TECHNICAL BULLETIN

No. 205-99-112

MODEL AFFECTED: 205A-1

SUBJECT: FORWARD CROSSTUBE, MODIFICATION OF

FIGURE 1

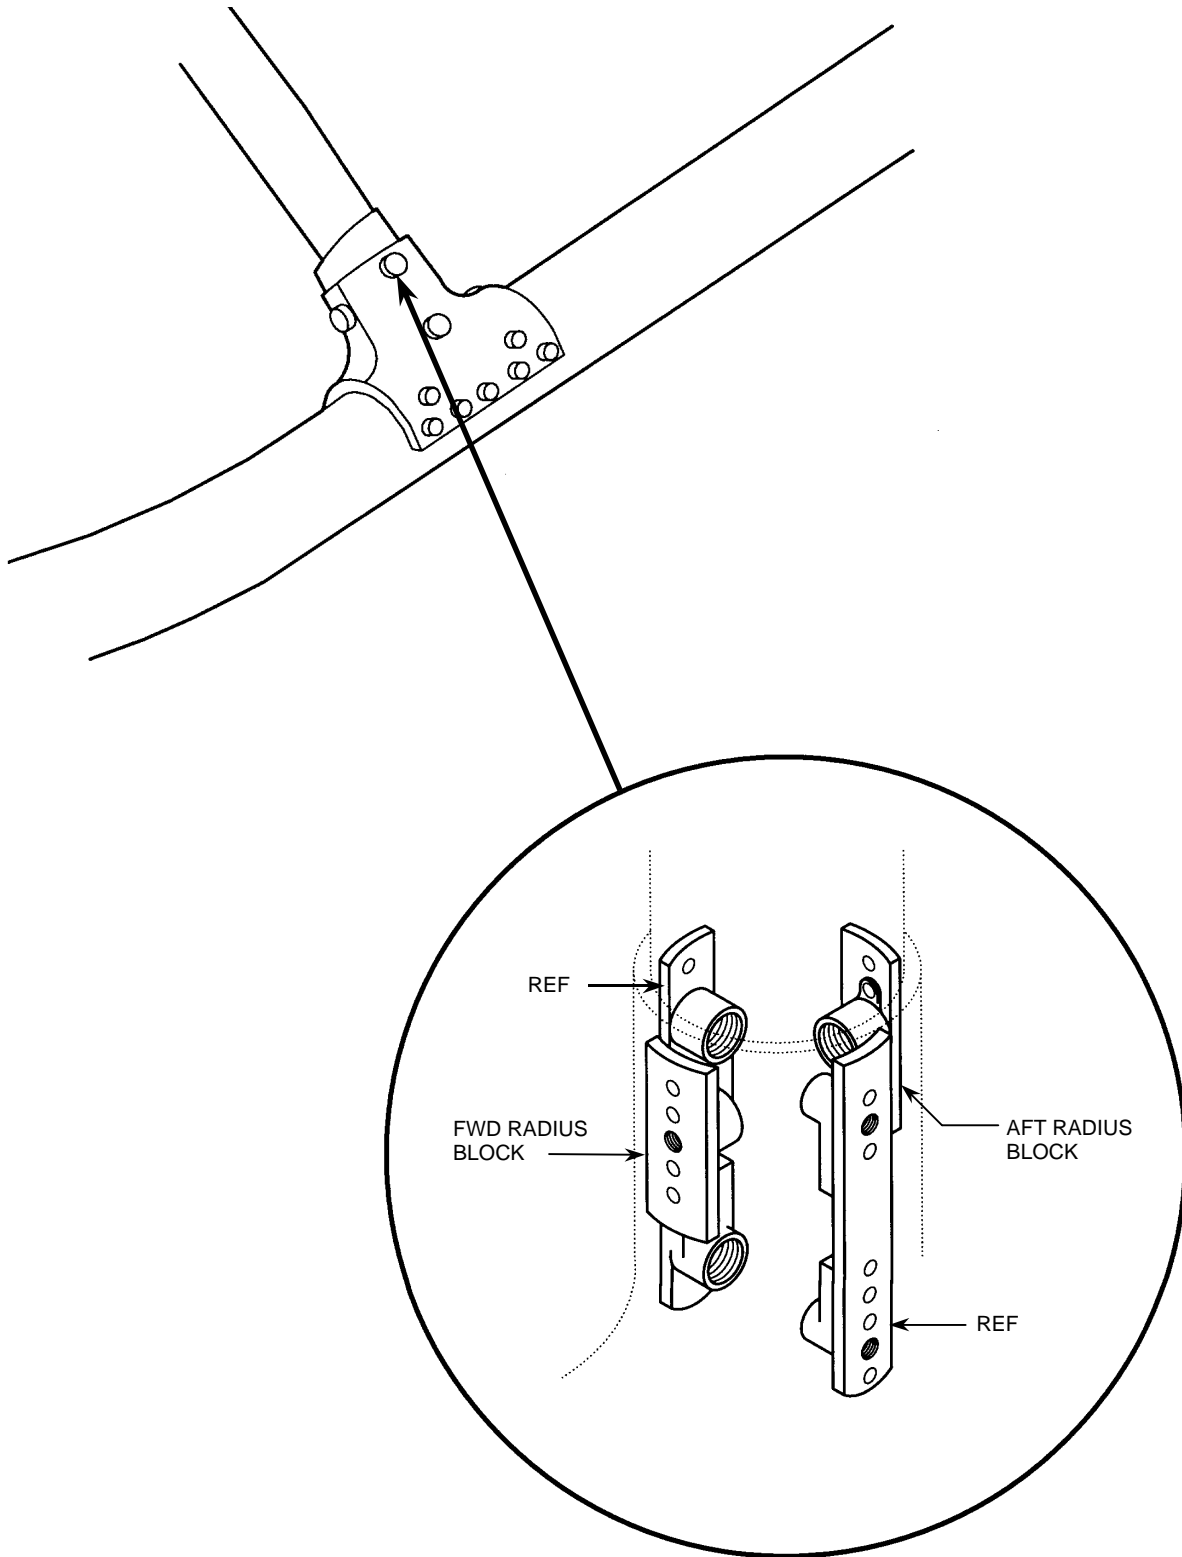
1. Remove and disassemble landing gear from helicopter as per maintenance manual to accomplish the forward crosstube modification.
2. Remove the forward and aft radius block assemblies P/N 90-019-2 via drilling off attaching rivets on the forward crosstube (ref. Figure 1).

3. Remove nutplates P/N MS21069L4 from the radius blocks assembly P/N 90-019-2.
4. Fill holes in radius block with P/N MS 20426AD3 rivets (double flush).
5. Enlarge the 0.264/0.270 inch holes in the 90-019-2 radius blocks to 0.403/0.410 inch.

6. Install new MS21069L6 nutplates with MS20426AD4 rivets in the previously reworked radius block. Radius blocks are now reworked to the 90-019-1 configuration.
7. Enlarge the two 0.265/0.272 inch diameter bolt holes in the fore and aft positions of the crosstube cuff to 0.385 / 0.392 inch.
8. Install 90-019-1 radius block assemblies in the fore and aft positions of the forward crosstube using P/N MS20426AD3 rivets.
9. Insure corresponding attachment holes in saddles are compatible and match. Re-assemble and install landing gear as per the maintenance manual.
